SERVICE LETTER 205

10000A Hopper Fill Control System Replacement

Aircraft Makes/Model(s):	Float Model(s):	Compliance: Optional	By: MAS
Air Tractor AT-802 and AT-802A	10000A	Part Number: 1011407	Approved: DRH
		Date: 8/25/2022	Revision: G

Figure 1 - 10A12665-001 Shield

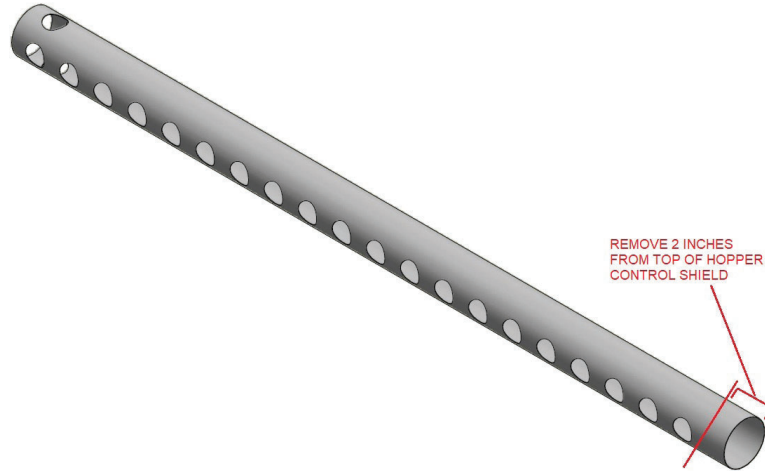
- Offwing, create the new fill sensor assembly as follows:
 - Remove and save the upper shield bracket, the shield, lower shield bracket, and set screws from the old fill probe assembly.
 - Discard the bottom tank mounting bracket and old fill probe/float.
 - Cut off 2" from the top of the 10A12665-001 shield. Deburr, prime and paint for corrosion protection. Reference Figure 1.

- d. Reinstall the lower shield bracket, the modified shield, and upper shield bracket onto the new fill probe, p/n 1011649.
2. Open up the 4 existing 3/16" mounting holes in the rear wall of the hopper to 3/8". Reference Figure 2.
3. Cut between the 3/8" holes for a 2.13" x 2.13" access hole. This will give access to install the connector on the new probe. Reference Figure 2.
4. Fit the new probe into the top upper bracket (10A12251-006) and center the foot over the 2.13" x 2.13" access hole. Transfer the 6 mounting holes in the foot of the new probe into the rear wall of the hopper using #10 drill bit. Reference Figures 2 and 3.

Figure 2 - Prepare the Bottom/Back of Hopper

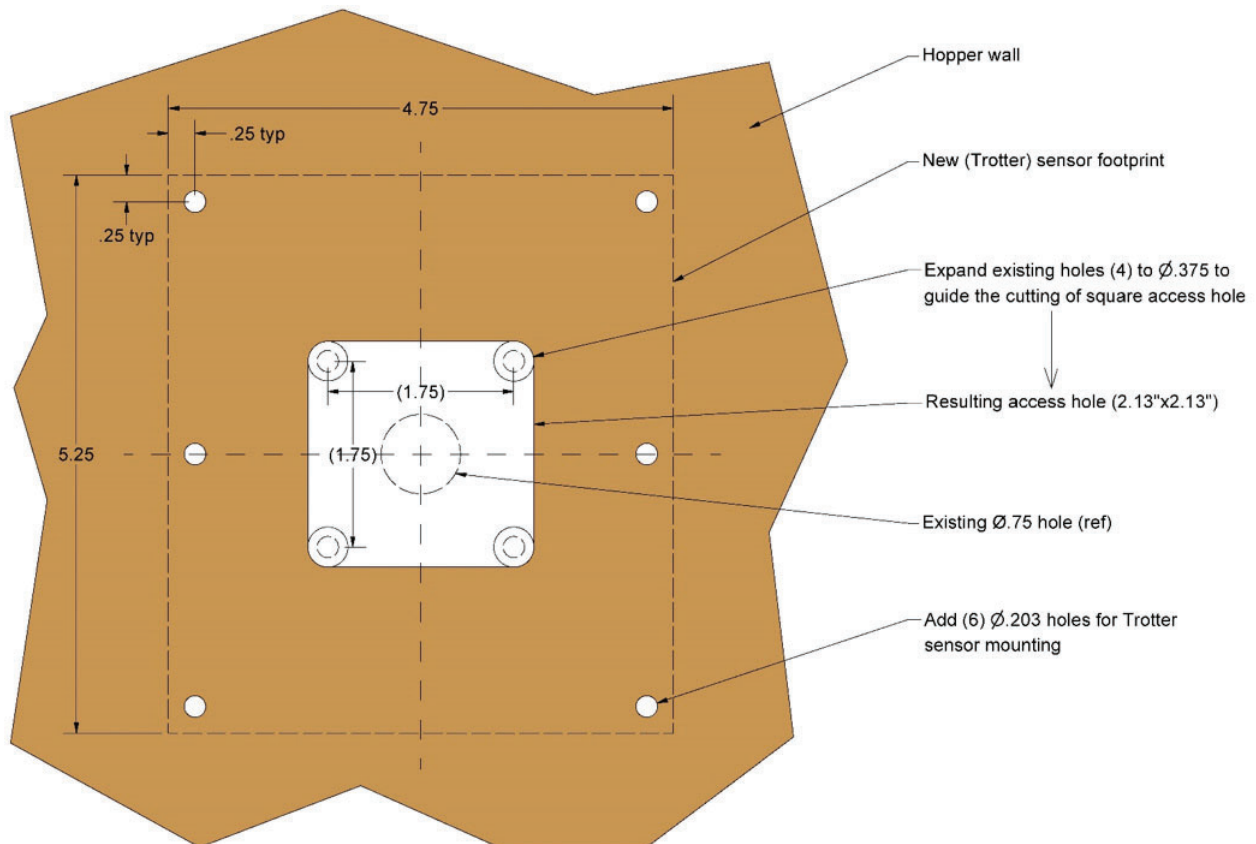
Note: A locally fabricated template may be used to assist in locating holes. See Figure 2 for pertinent dimensions. The 4 existing mounting holes are recommended reference points, before cutting the square access hole.

Figure 3

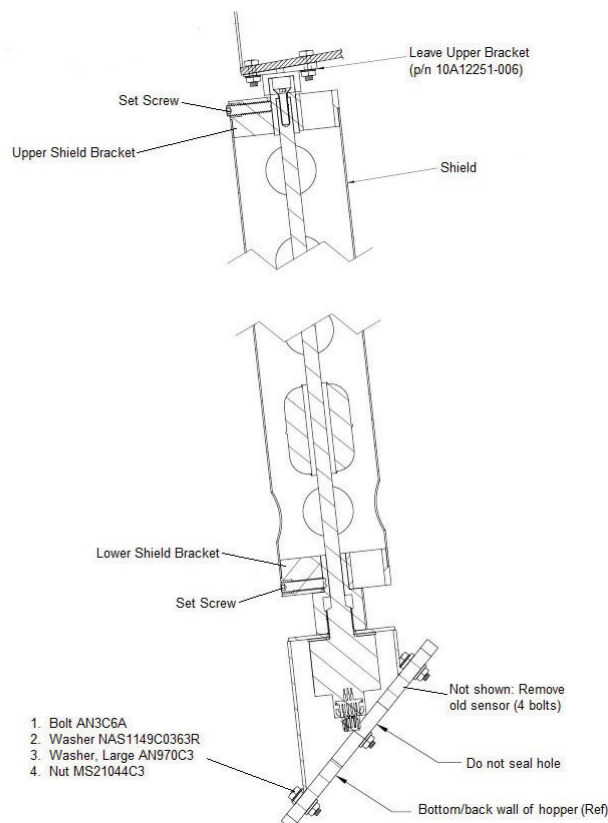
- Remove old (Amtech) fill sensor assembly and wiring from hopper.
 - Leave in the upper bracket (10A12251-006) bolted to the top of the hopper. Reference Figure 3.
 - Remove and discard the 4 bolts mounting the probe to the back wall of the hopper. Reference Figure 3.
 - Disconnect wiring harness at red connector behind panel in cockpit.
- Remove old (Amtech) fill display screen and wiring from panel.
 - Disconnect yellow connector from rear of screen.
 - Disconnect 3 wire connector (P-17).
 - Remove adjustment knob.
- Disconnect blue connector from rear of screen, one wire comes out of blue connector and goes to P-16/Pin 2. Cut this wire at butt splice.

Figure 4 - New Fill System Schematic

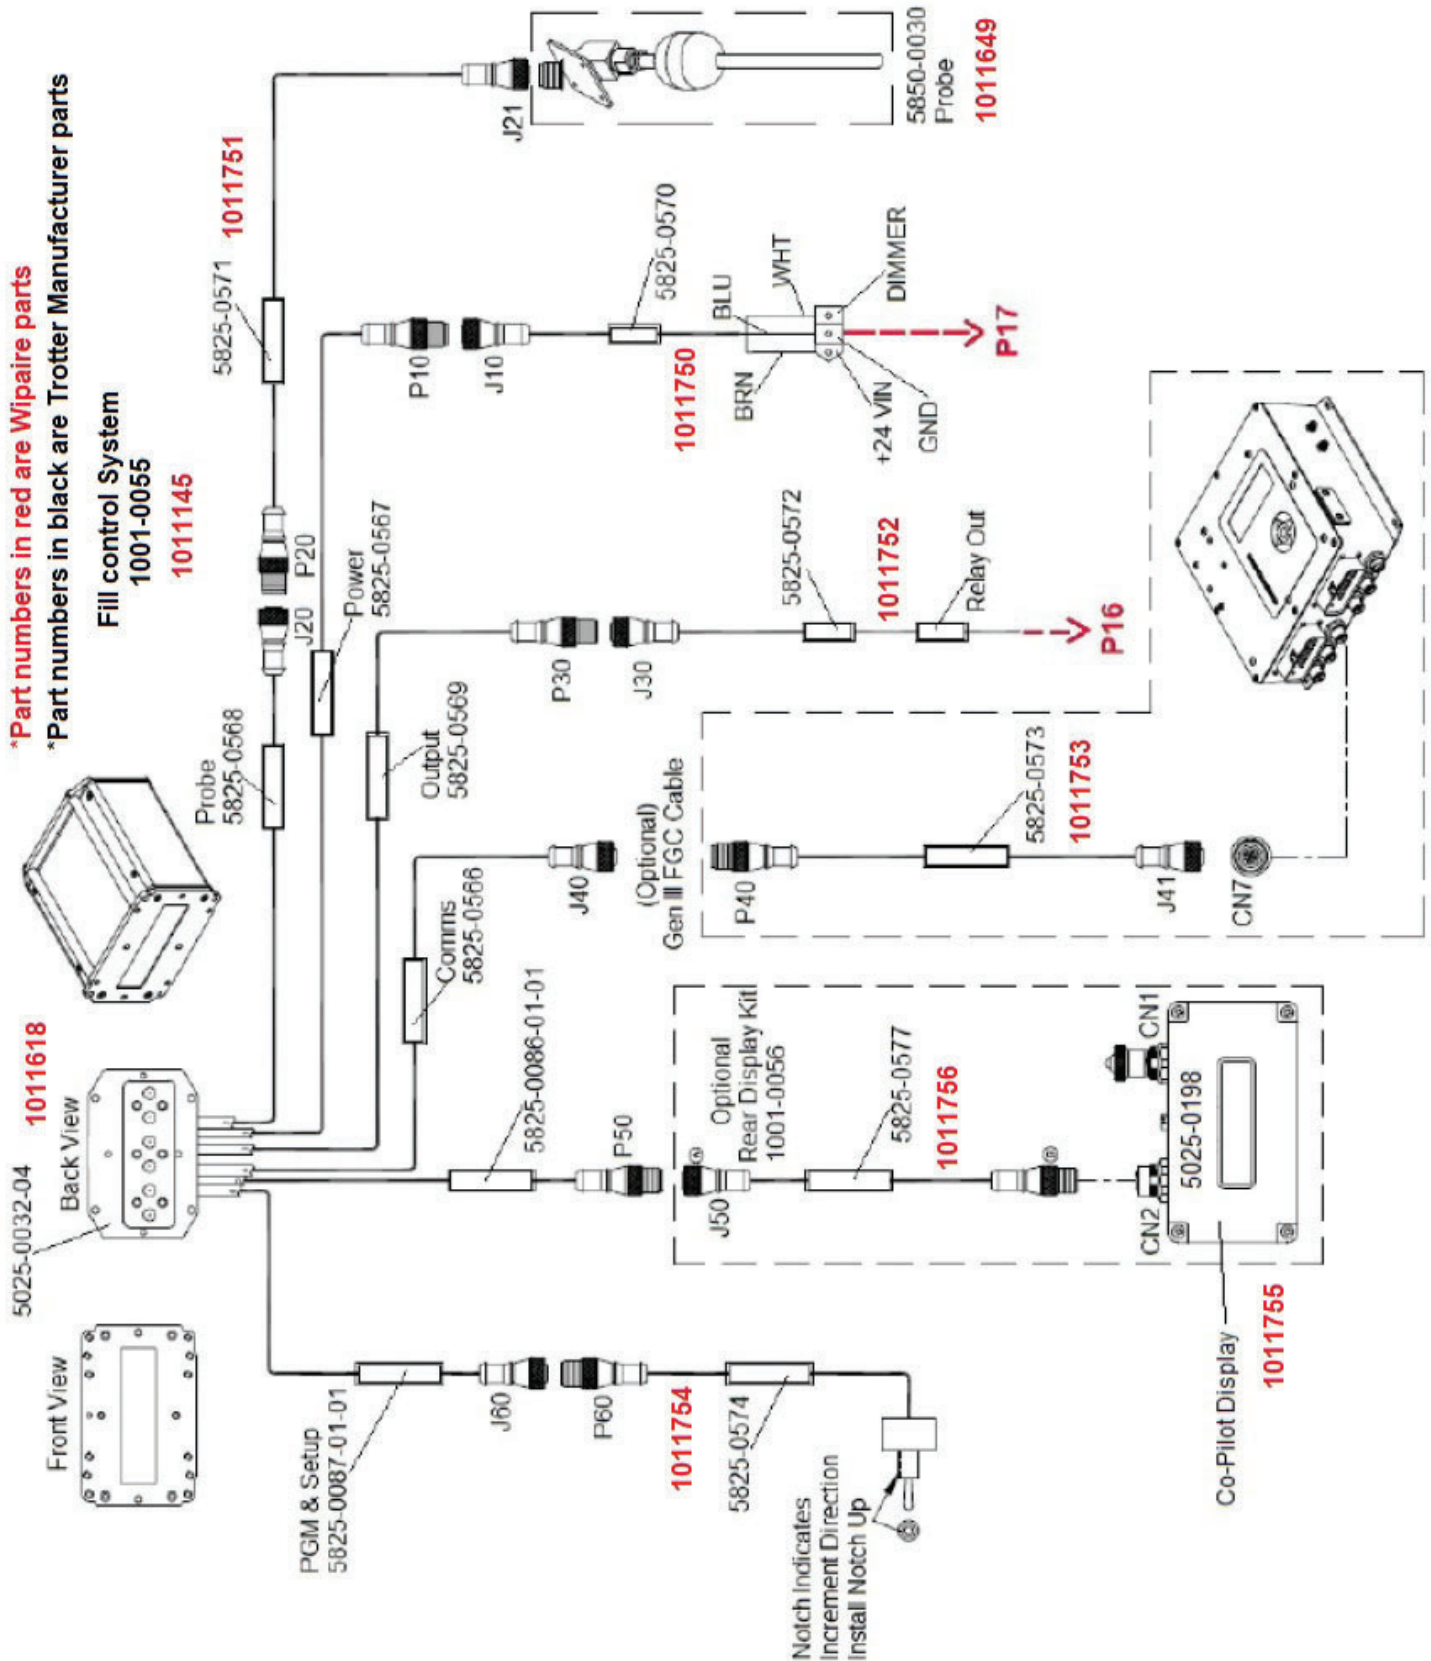
Note: Reference Figure 4 for steps 6-11:

6. Install cable PN 1011751 onto the probe and route through floor access boot into the cockpit and behind the panel.

7. Install the new display p/n 1011618 in the panel

Note: The new display is longer than previous display. Adjustments to components behind the panel (cable routing, for example) may be necessary.

- a. Place the mounting gasket, included with the display unit, onto the faceplate. Align gasket to the 4 mounting holes.
- b. Apply threadlocker (Loctite 242 (blue) or equivalent) to the (4) #6-32 screws included with the display.
- c. Install the display from behind the panel and secure with the screws from step 7b. Torque to 9 in-lbs.
- d. Connect PN 1011751 by connecting J20 to P20.

8. Install scoop qty. switch assy PN 1011754 in panel and connect P60 to J60.

9. Install harness PN 1011752 by connecting J30 to P30.

- a. The white wire in this harness connects to the scoop relay P16/Pin 2 with a butt splice.

10. Install harness PN 1011750 by connecting J10 to P10.

- a. The other end plugs into P-17.

11. If installing in a dual cockpit with a rear instrument panel the rear display kit is optional, see P/N 1011755 Copilot Fill Level Display and P/N 1011756 Wire Harness for Copilot Fill Level. in Figure 4. If mounting to existing panel is not feasible or desired, kit 1011750-02 provides for an alternate mounting option. See Figure 5. Use the socket head screws (item 23) and pan head screws (item 24) to fill their respective mount holes in the display regardless of mounting option.

Figure 5 - Optional mounting of co-pilot fill display

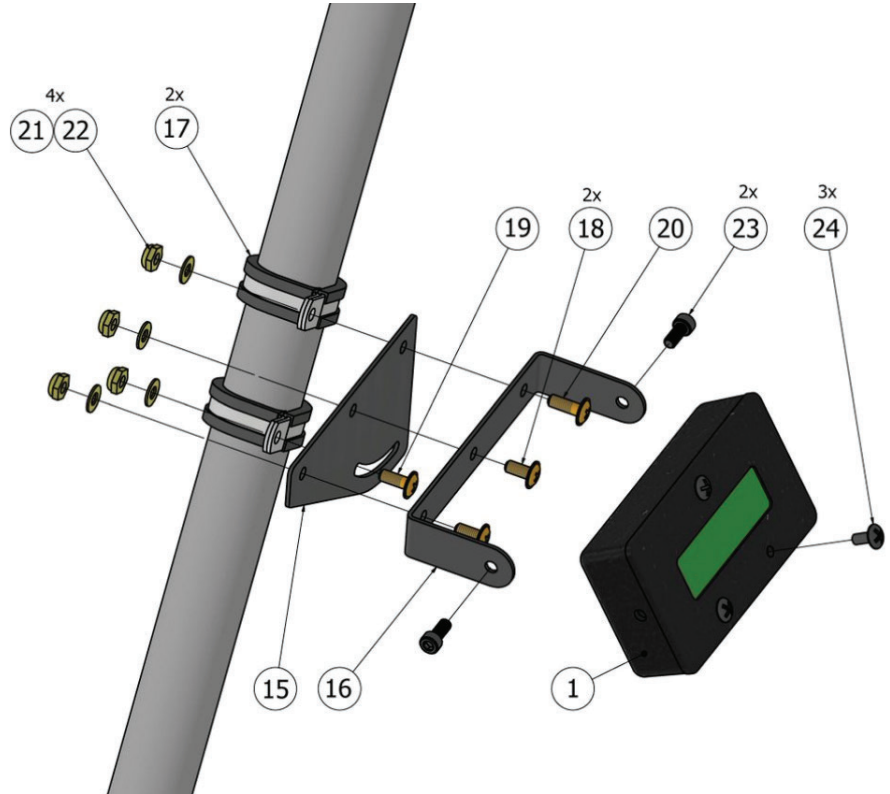
(Item numbers correspond to Kit 1011407-02, see table)

Figure 6 - Adapter Plate Installation

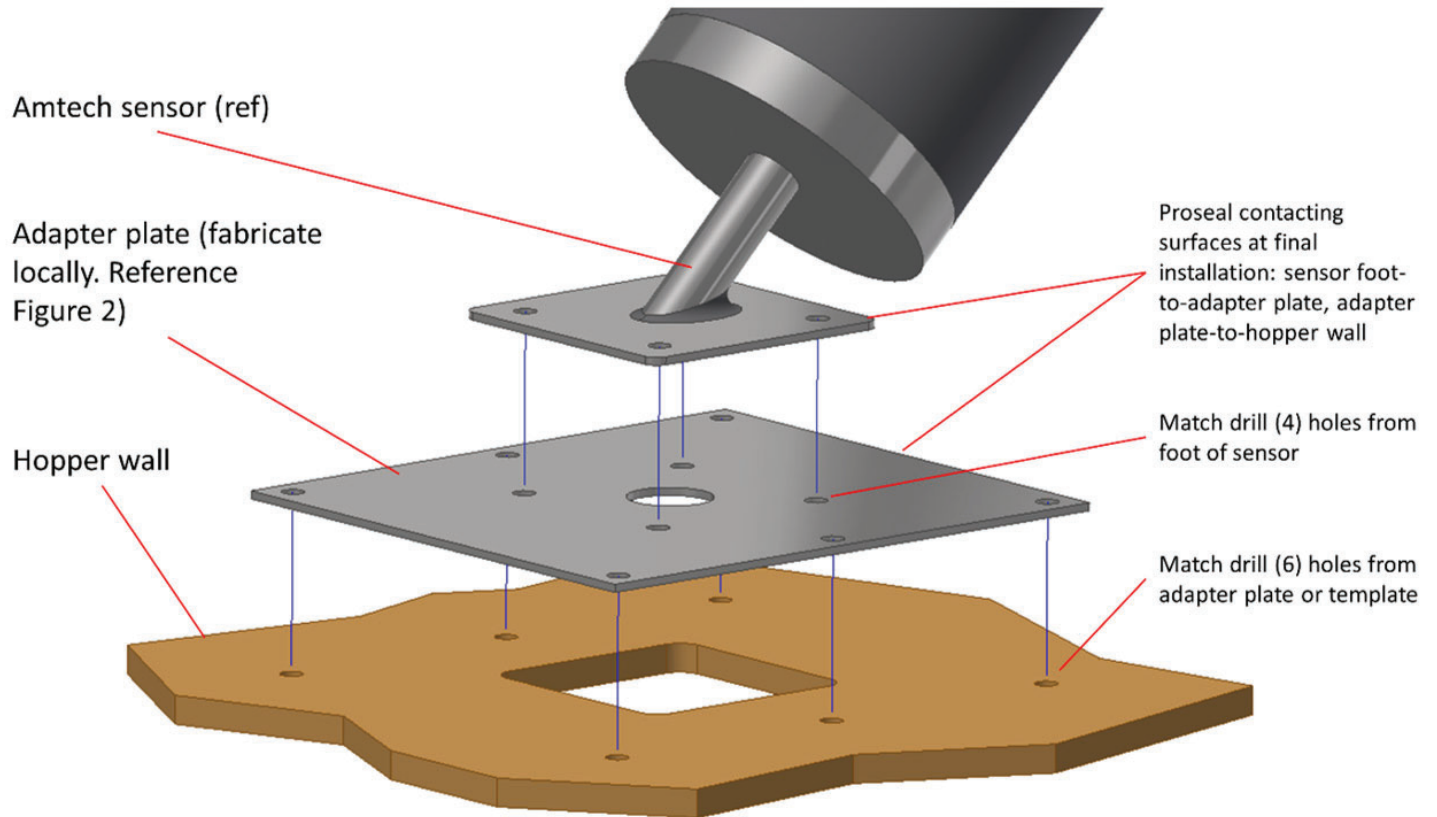
1. Temporarily dismount Amtech fill sensor.
2. Locally fabricate adapter plate matching the new (Trotter) footprint and containing the center $\frac{3}{4}$ " hole as well as the 6 new mount holes for the Trotter sensor. Reference Figure 2. Plate to be made from 0.070" stainless steel, grade 301, 304, or 316.

- a. Match drill the 4 holes for mounting the Amtech sensor into the adapter plate. Reference Figure 6.
 - b. Match drill the 6 outer holes from the adapter plate into bottom/back wall of the hopper. Reference Figure 6.

5. Install Adapter Plate and re-install Amtech sensor using proseal and new hardware. Reference Figure 6.
